STAFF RECOMMENDATION
903 Waldkirch Avenue
June 15, 2016

Application: New construction – addition (constructed without a permit); Setback determination

District: Waverly Belmont Neighborhood Conservation Zoning Overlay

Description of Project: The applicant proposes a side addition to a non-contributing house. The addition was constructed without obtaining permits and requires a setback determination.

SITE PLAN

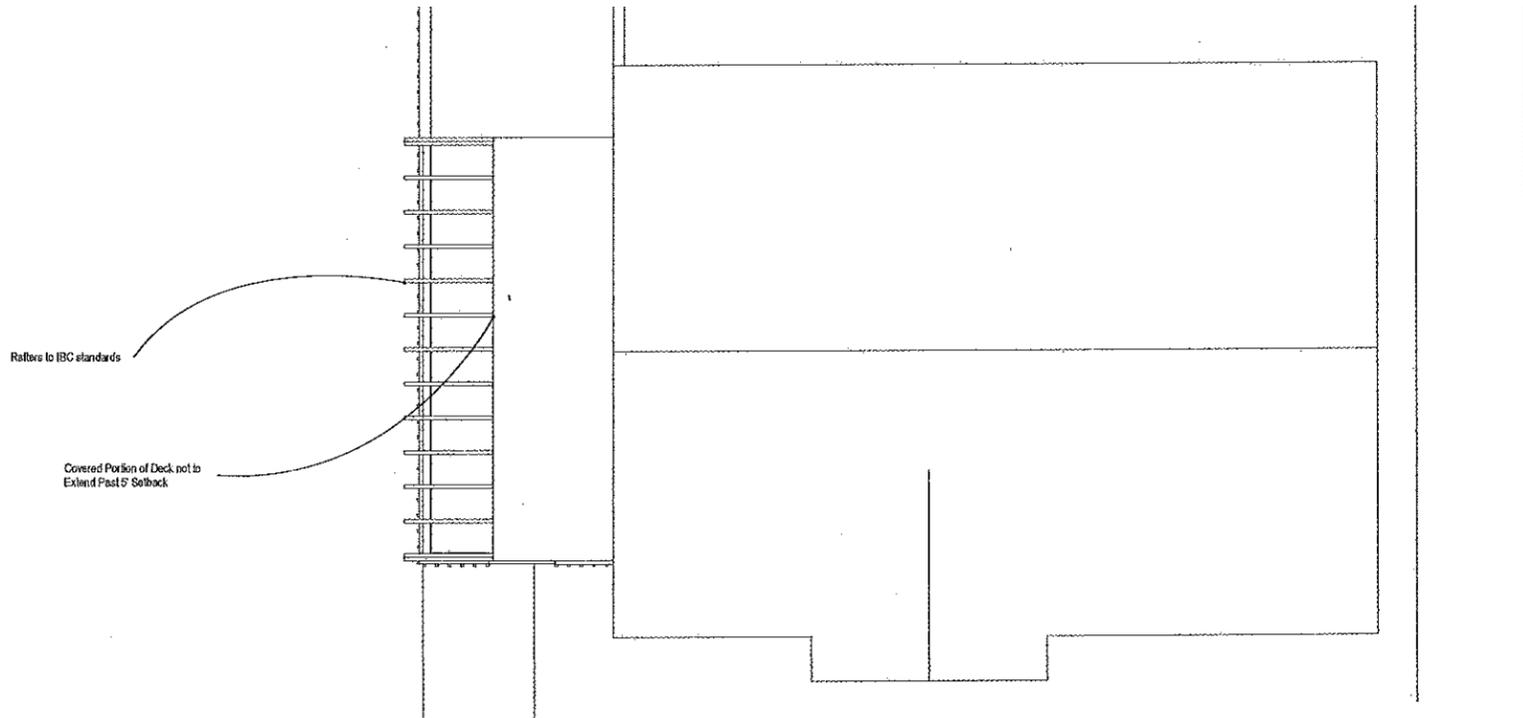
Design, Location & Removability: The addition is located on the left side of the house, nearly flush with the front corner. The fully covered portion of the deck will extend three feet, eleven inches (3' 11") toward the left property line, and a trellis will continue the remaining five feet (5') to the side property line. The entire deck extends back thirty-one feet, ten inches (31' 10"), with the covered portion extending back approximately nineteen feet (19').

Setback: The existing covered deck is located on the left side property line. The Zoning Code requires a minimum side setback of five feet (5'), and the applicant proposes to accommodate this by replacing part of the roofing with a trellis. However, the trellis portion of the deck, which extends to the side property line, does not meet the required minimum side setback of five feet (5'). Setback determinations take into account historic conditions; however, this proposal does not meet any of those conditions where setbacks less than those required by codes have been approved. In addition, a wider side addition on this lot disrupts the rhythm of spacing along the street. Therefore, staff finds that the project does not meet Section III.C for setbacks.

PROPOSED COVERED DECK:
1/4" = 1'-0"

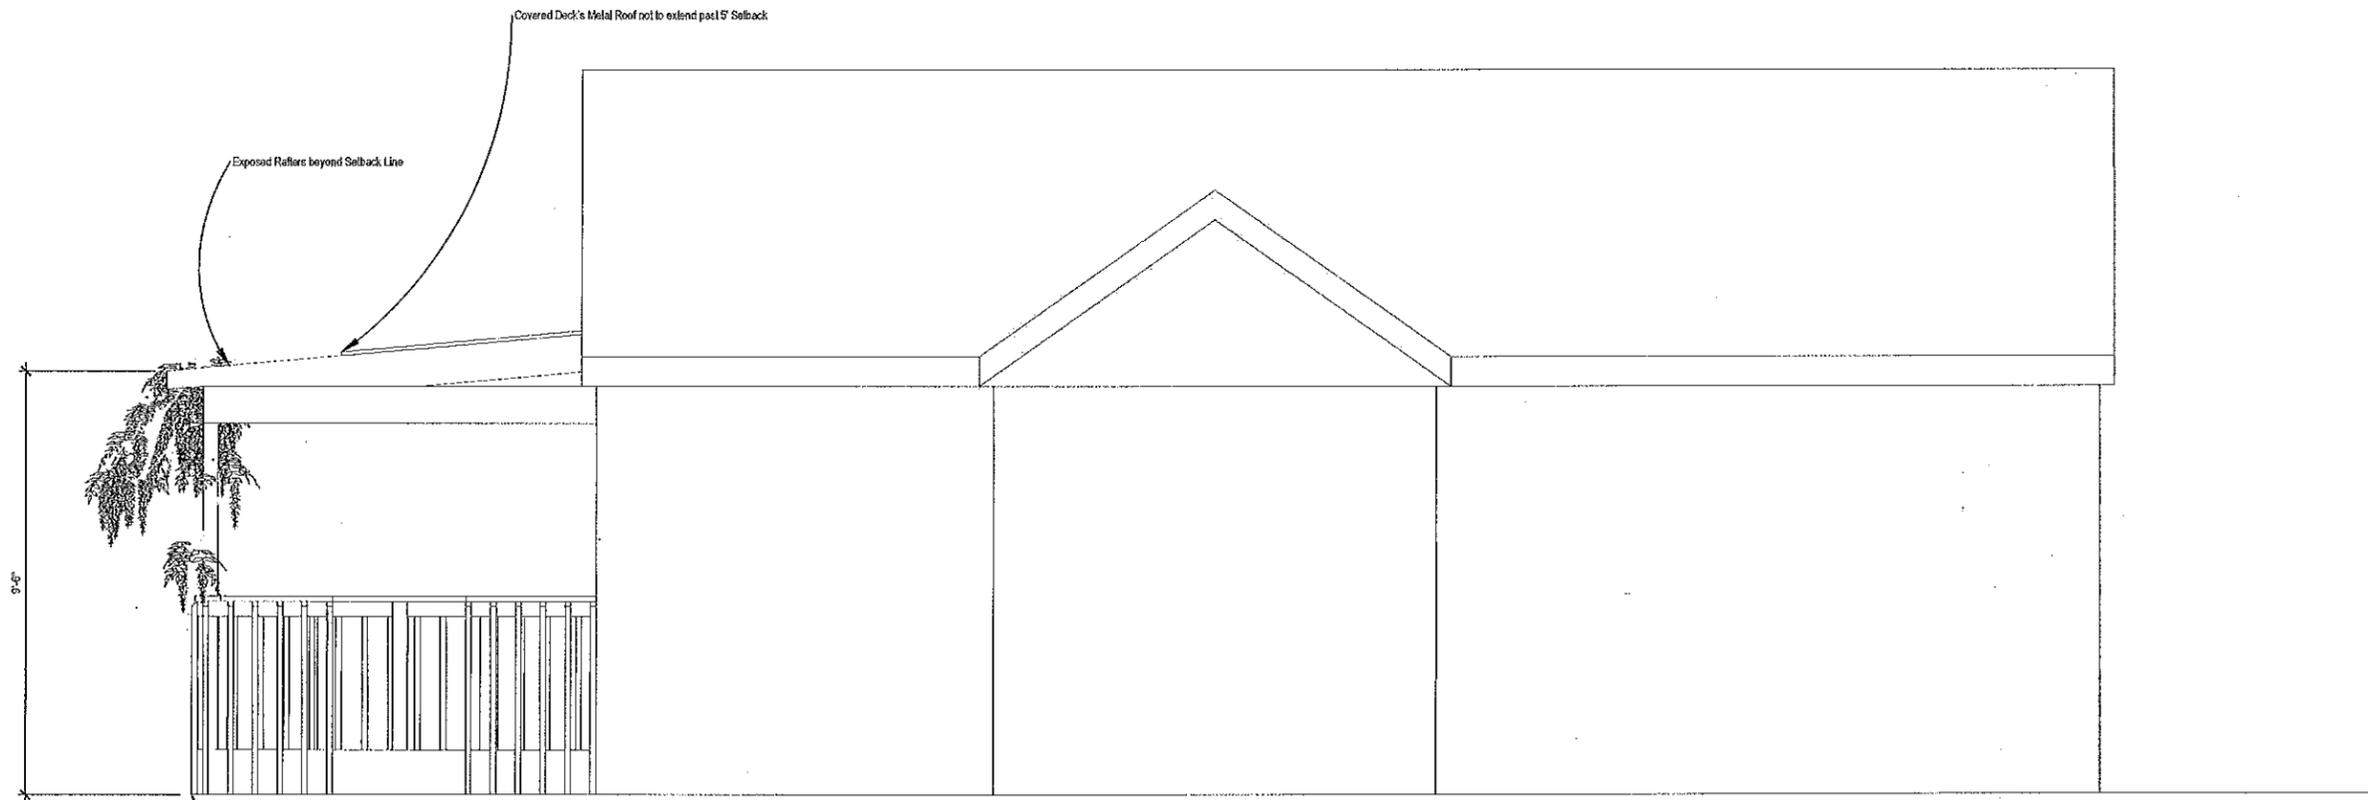
Height & Scale: The addition has a maximum height that is approximately six feet, six inches (6' 6") lower than the ridge of the historic house. Eave height on the addition is also similar to that on the existing house.

Materials: The deck is constructed of wood, and the plans indicate that the roof will be a metal roof with exposed rafters for the trellis. The existing and proposed materials for the covered deck could be appropriate if the deck were located at the rear of the house. However, staff finds that the materials are not visually compatible on a public façade as decking materials are generally not seen from the street. Therefore, staff finds that the project does not meet Section III.D.

Roof form: The roof form of the addition is a low pitched, shed-style roof. However, this is inappropriate as it will be seen from the front of the house. The project does meet Section III.E.
